CITY OF AURORA
BUILDING DIVISION
APPROVED AS NOTED
DATE: 01-17-2008
APPROVED: 01-17-2008

#710 AURORA COLORADO
CHUCK E. CHEESE'S
MINOR BUILDING REMODEL
14005 E. EXPOSITION AVE AURORA, CO 80012

City of Aurora Plan Review

PROJ NO.	27925
DRAWN	
CHECKED	
ISSUED/REVISED	DATE
DESIGN REVIEW	11/09/07
PERMIT/PRICING	01/09/08
REVISION	
CONSTRUCTION	
REVISION	
REVISION	
REVISION	
DRAWING TITLE	
DEMOLITION PLANS

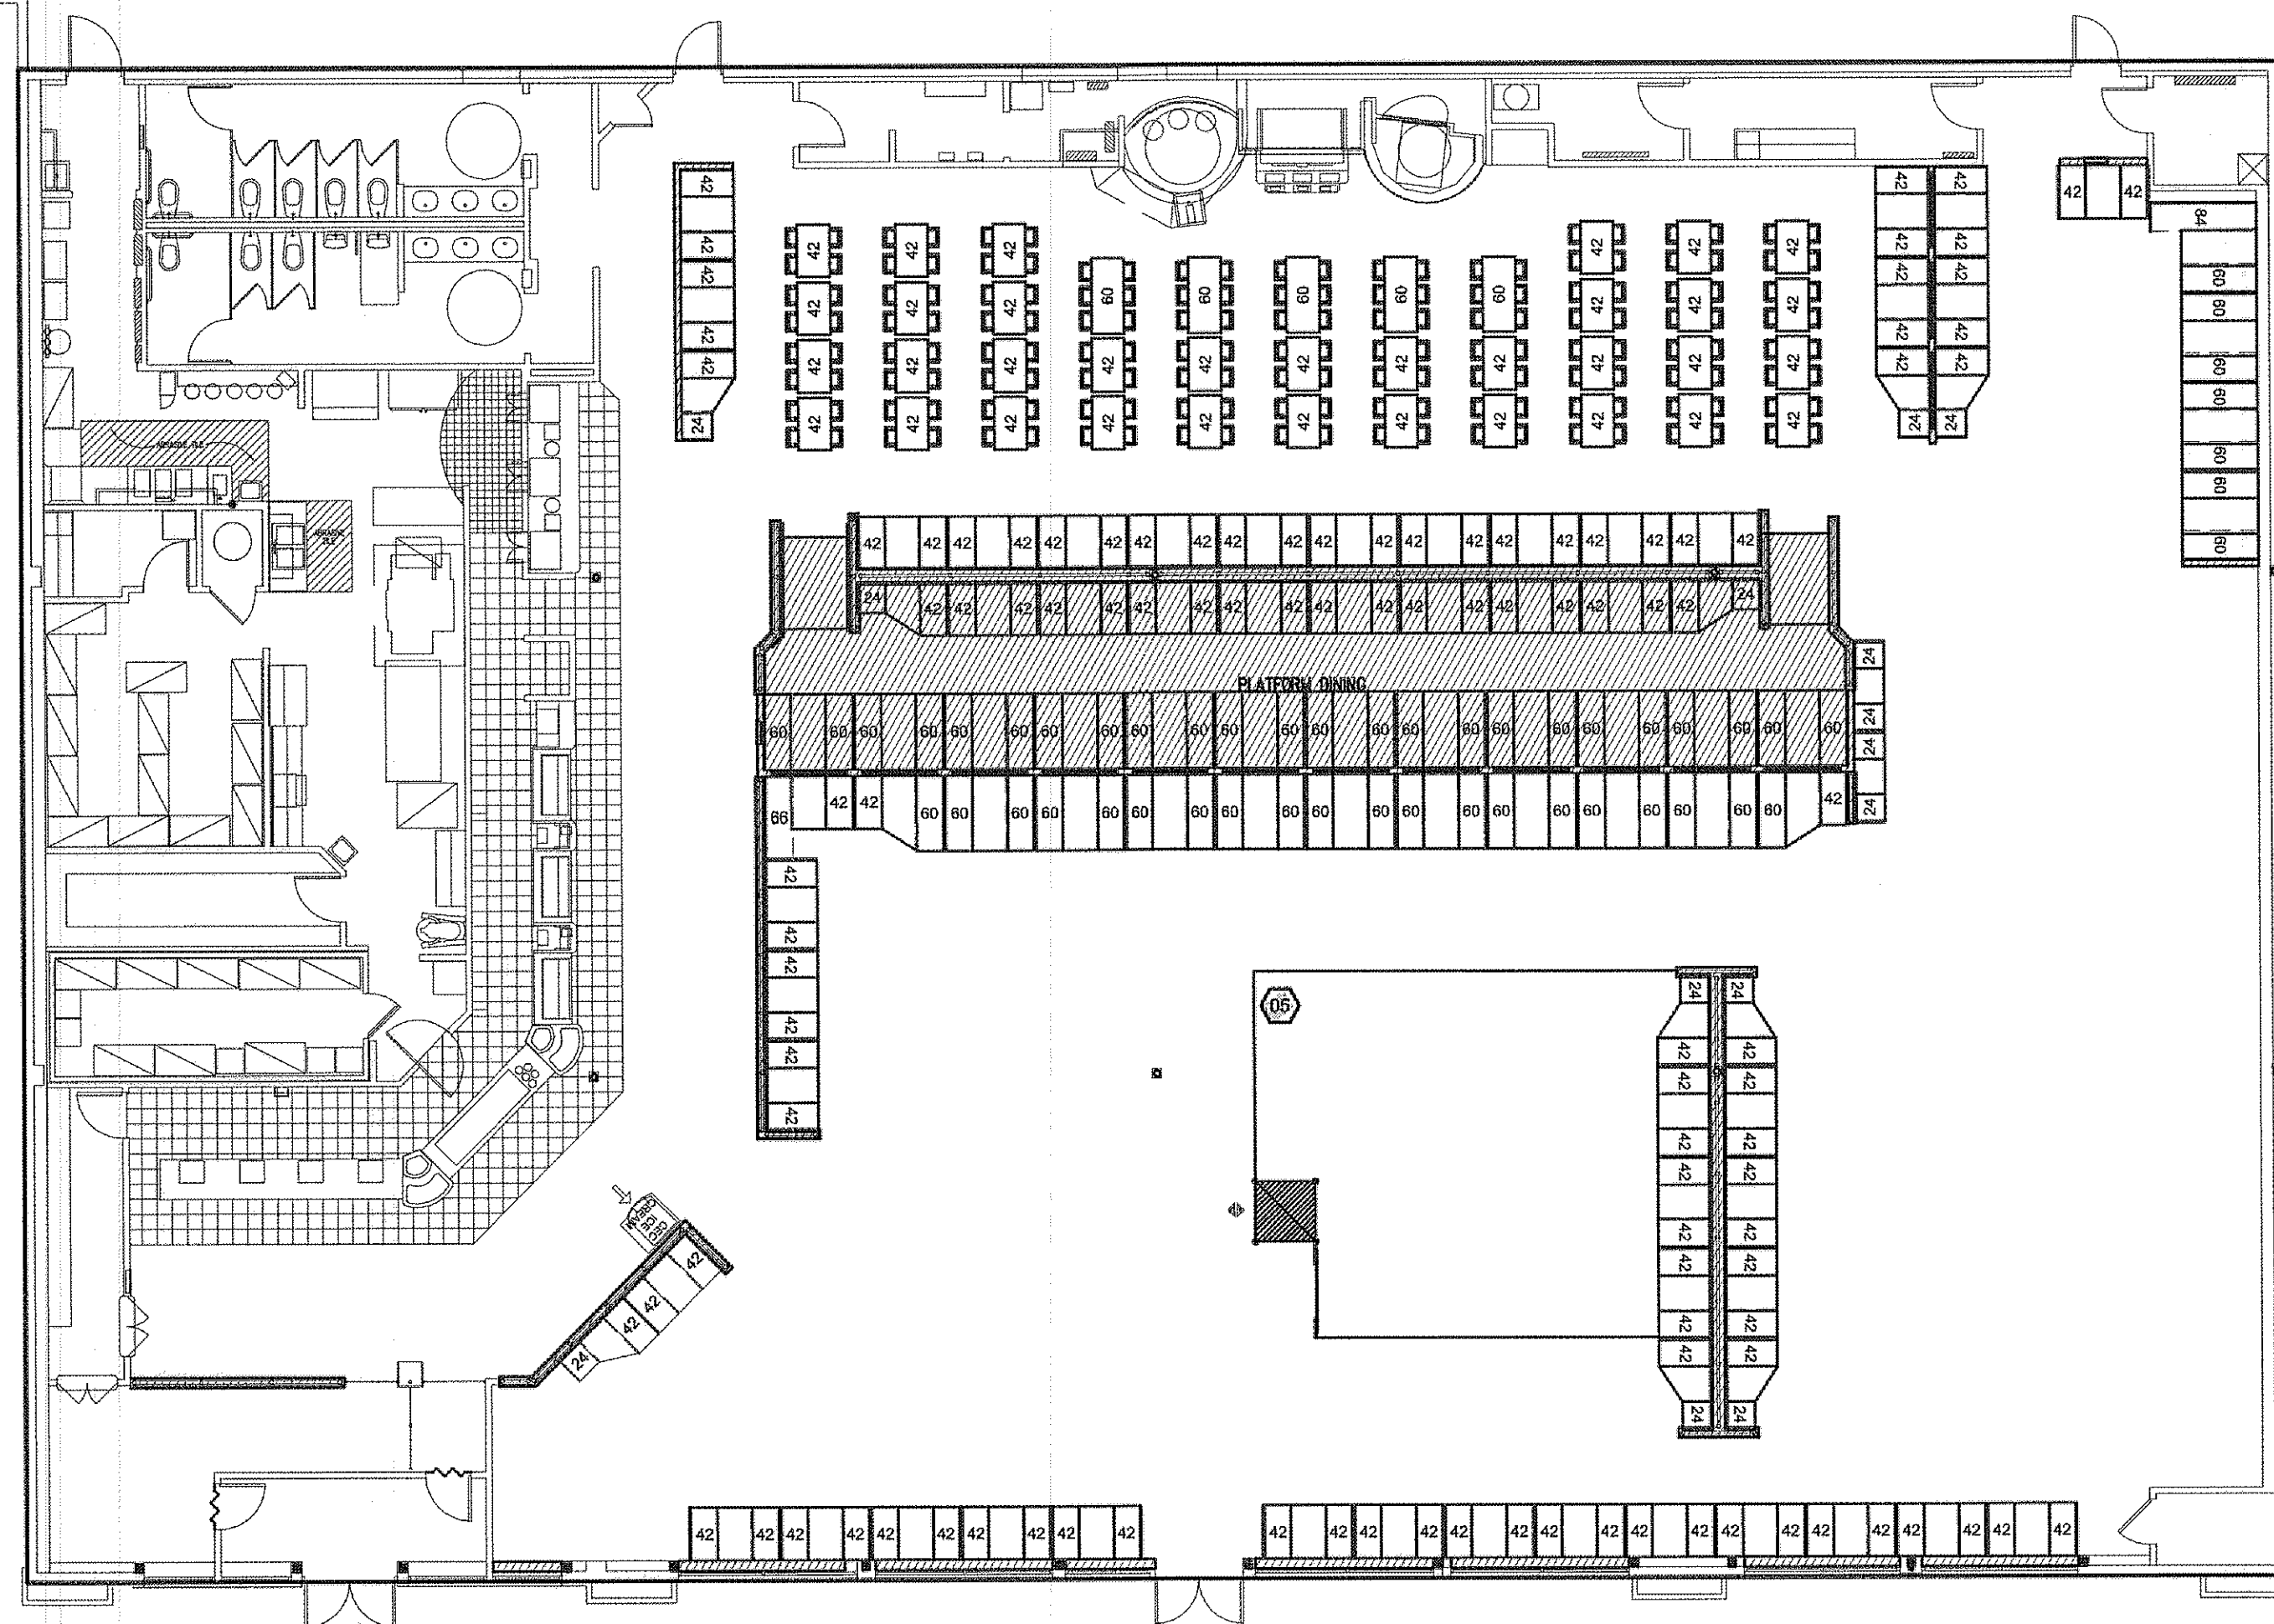
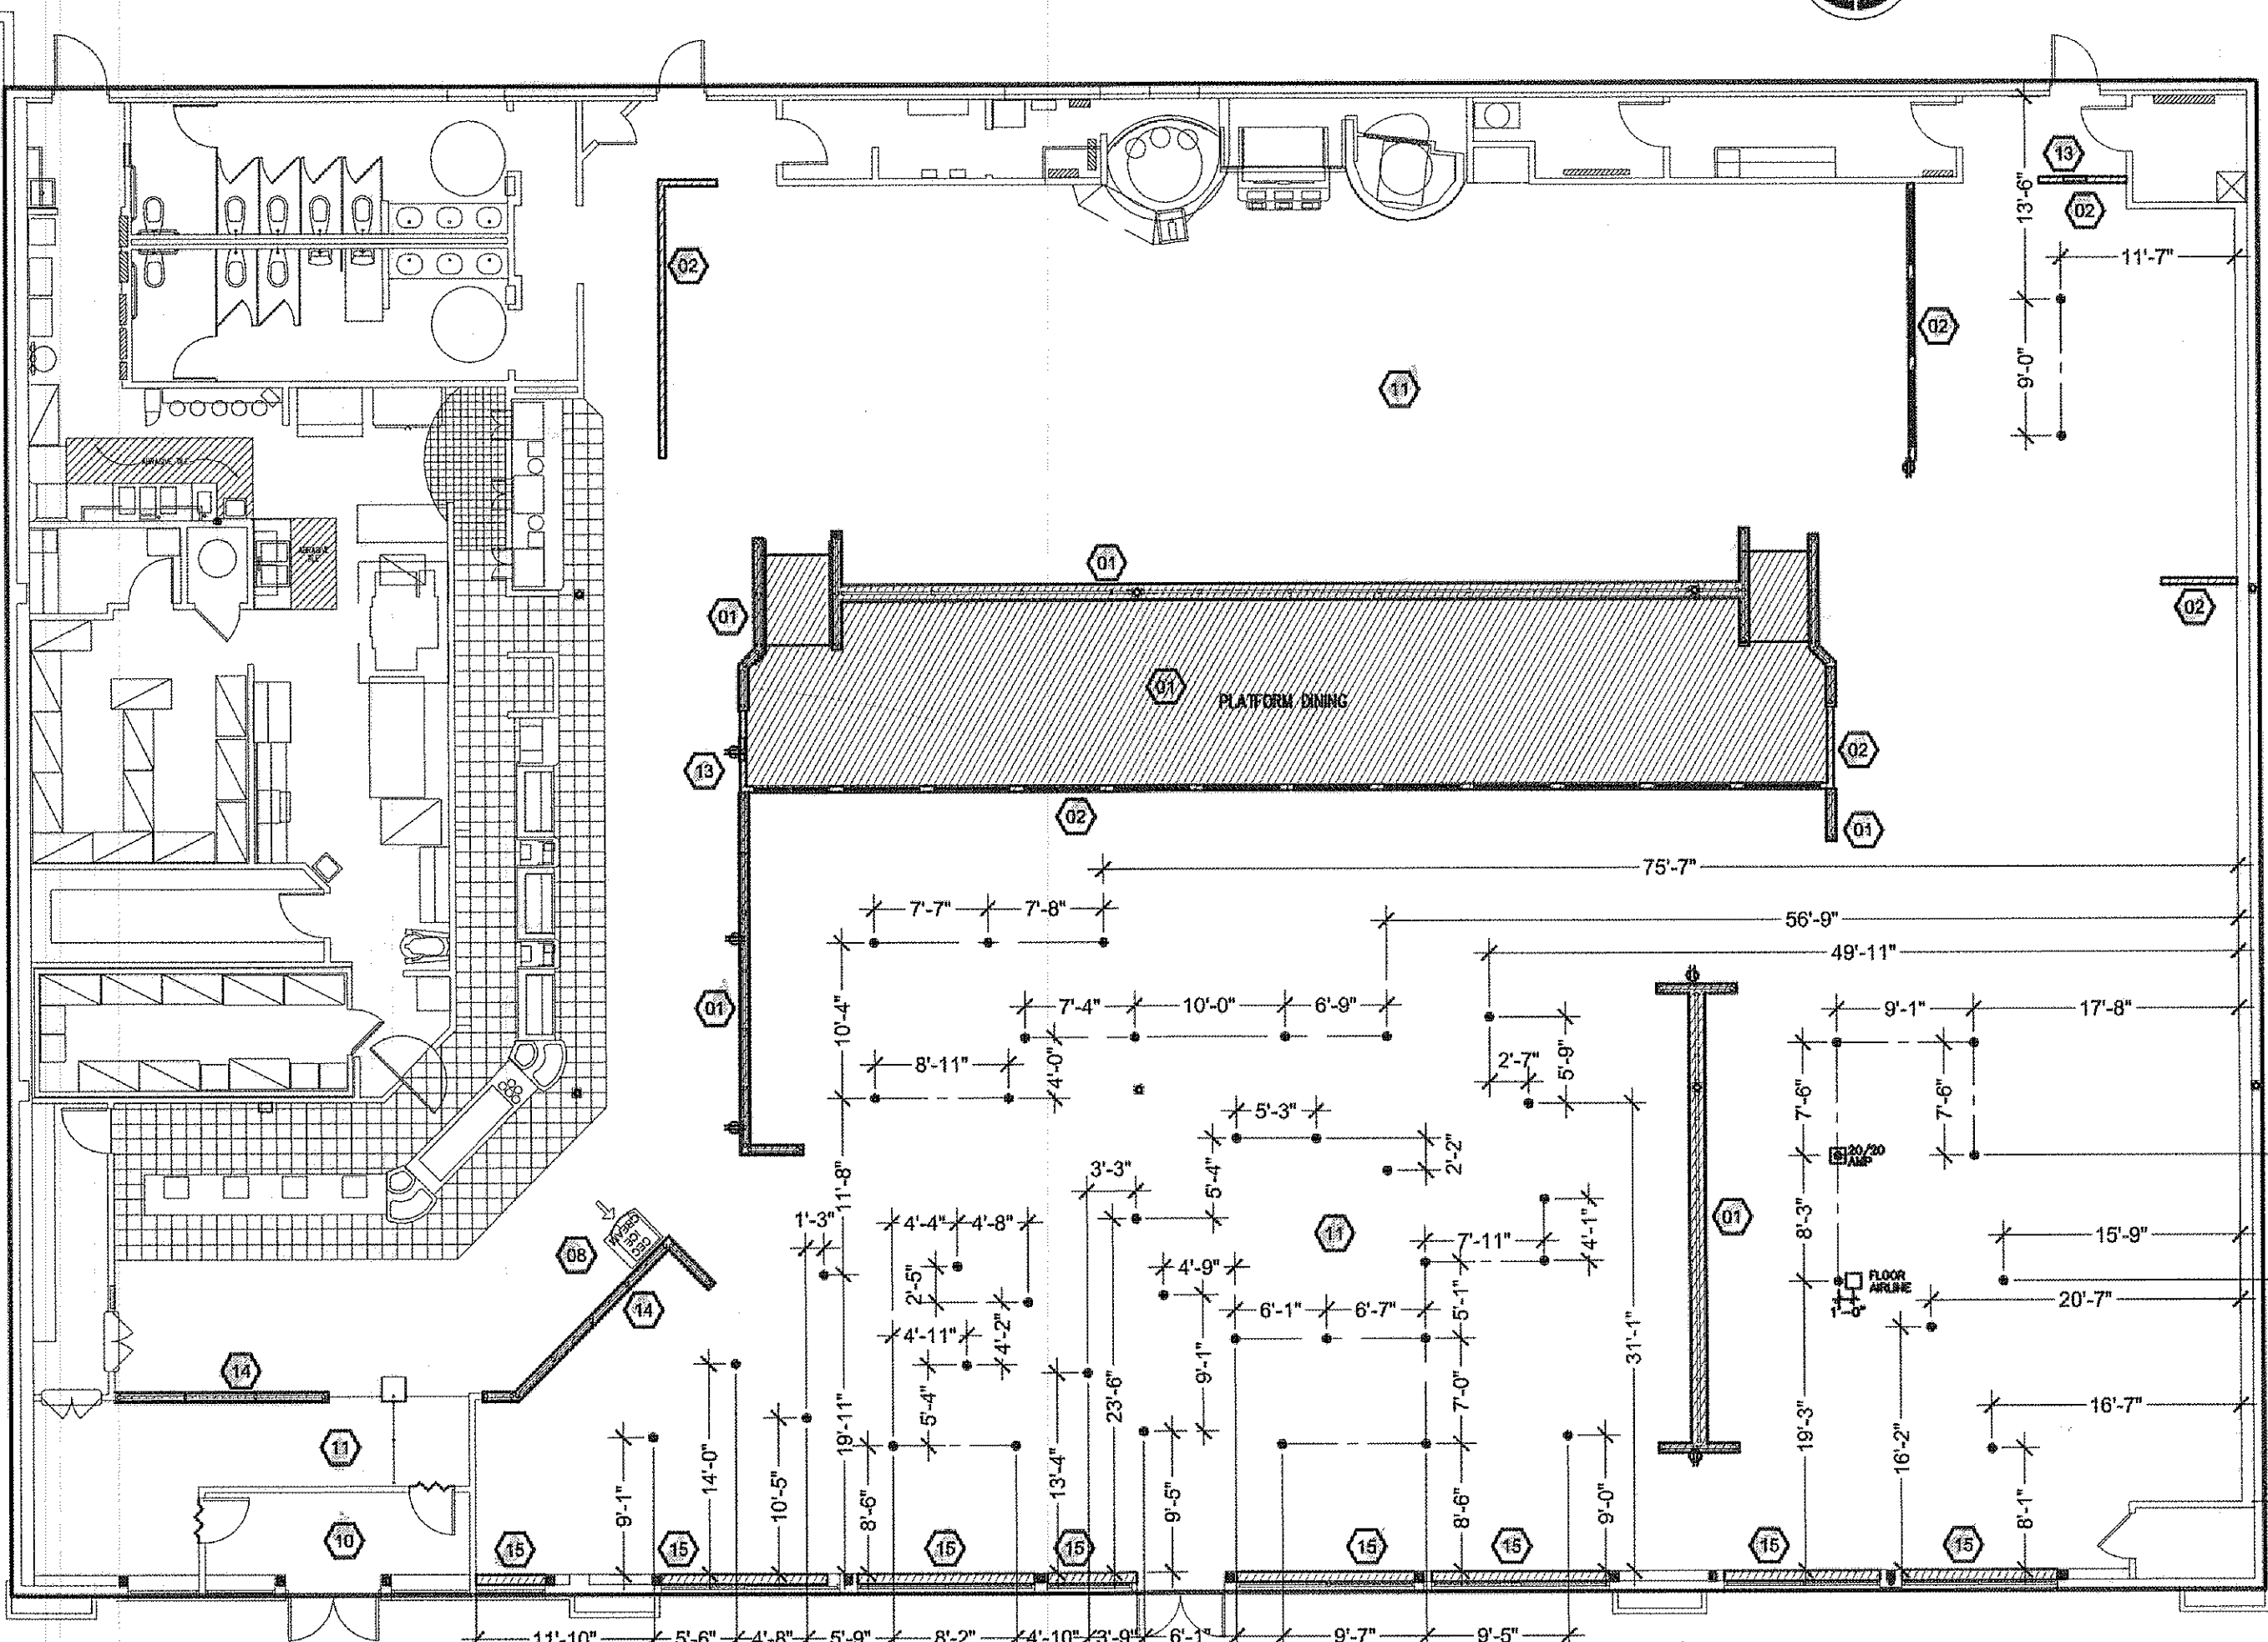
Consultation for fire extinguisher placement is available upon request. Call 303-739-7420 prior to final Life Safety inspection to verify proposed locations.

Provide U.L. Class 2A/0BC minimum rating fire extinguishers at a maximum 75'-0" travel distance prior to the Certificate of Occupancy issuance (2008 IFC Table 906.3(1) and 2002 NFPA 10)

Separate Life Safety drawings will be required for new systems or alterations to existing fire sprinkler systems. Plans must show sprinkler head locations, piping sizes and hydraulic calculations (if needed) and product cut sheets. Approval of the plan set is required prior to a request for inspection.

Separate Life Safety drawings will be required for new systems or alterations to existing fire alarm systems. Plans must be shown with device locations, one line diagrams, battery calculations and product cut sheets. Approval of the plan set is required prior to fire alarm inspection.

Important: If a concealed space enclosed wholly or partly by exposed combustible construction is not shown on the approved plan submittal, and is discovered in the field, it shall be sprinkler-protected as required by the 2002 NFPA 6-14.1.
